Re: Item 20.25; 150 Hamilton Street – Application to Injure Private Tree

Re: Addendum to Pruning plan for tree #5 at 154/150 Hamilton Street, Toronto, Ontario. Original Report, June 2, 2014, Revised report, May 9, 2016

Re: Pruning plan for tree #5 at 154/150 Hamilton Street, Toronto, Ontario. Original Report, June 2, 2014, Revised report, May 9, 2016

Figure 4: Schematic of proposed removal cuts on other limbs, showing approximate branch sizes.

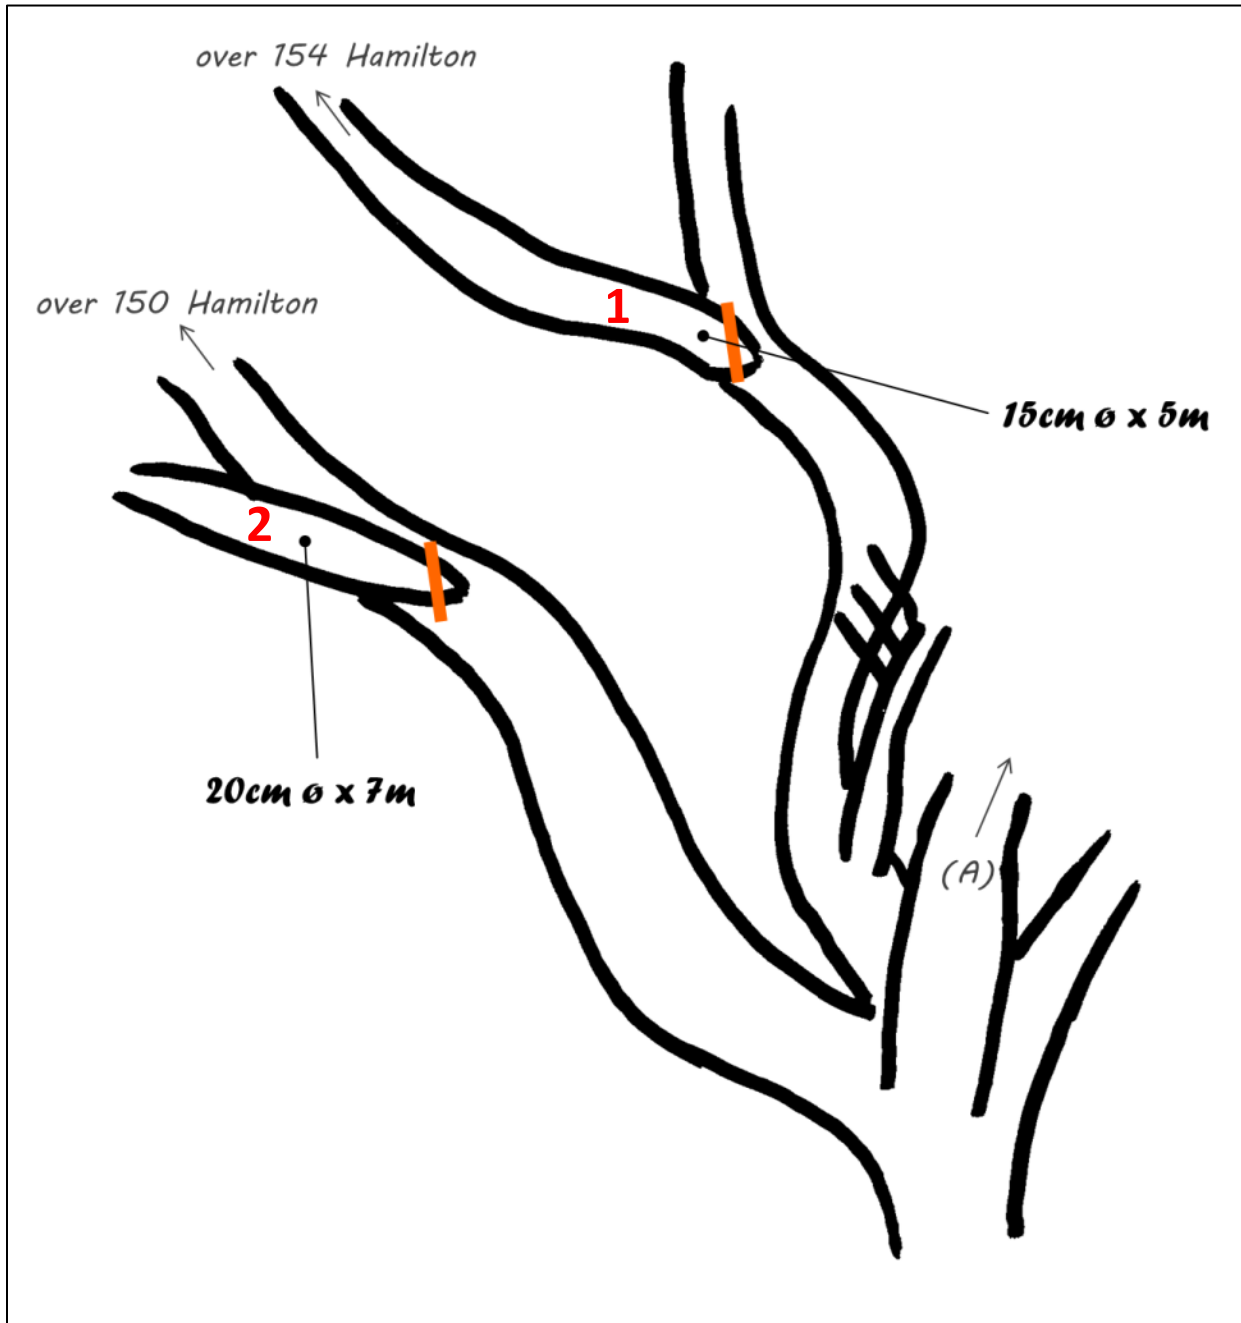
As previously described, in order to enable the proposed site works, pruning (removal cuts) of five scaffold branches and several additional small (< 3 cm diameter) branches will be required. The proposed locations of removal cuts for the five scaffold branches are shown in Figures 2-5. Red numbers have been added to Figures 4 and 5 to identify specific branches. The following comments pertain to those specific branches.

Figure 9: Possible pruning alternative for Branch 4.

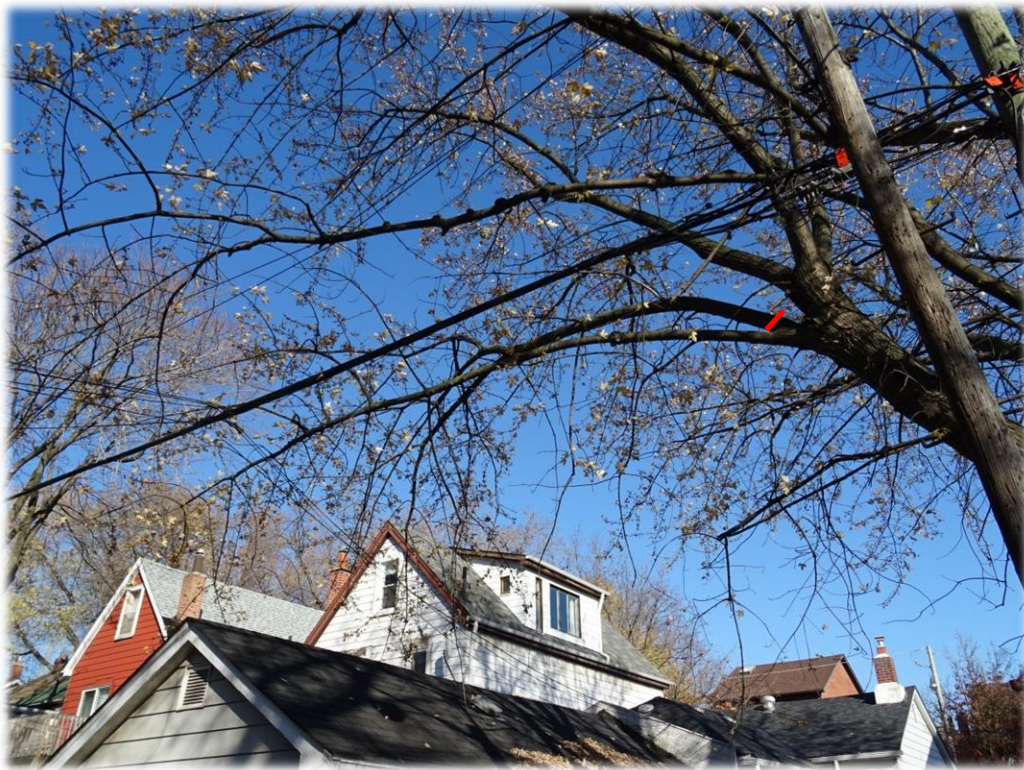
4. Branch 4 - This branch is also growing directly over 154 Hamilton. Removal of the whole branch may be avoidable by removing one side where the branch has its first major fork (Figure 9). This would be determined once the rear outside wall was built on the proposed structure. We recommend removing one side initially and the second branch only if required.
5. Branch 5 - This branch is also growing directly over 154 Hamilton. Removal of the whole branch may be avoidable by removing one side where the branch has its first major fork (Figure 10). This would be determined once the rear outside wall was built on the proposed structure. We recommend removing one side initially and the second branch only if required.
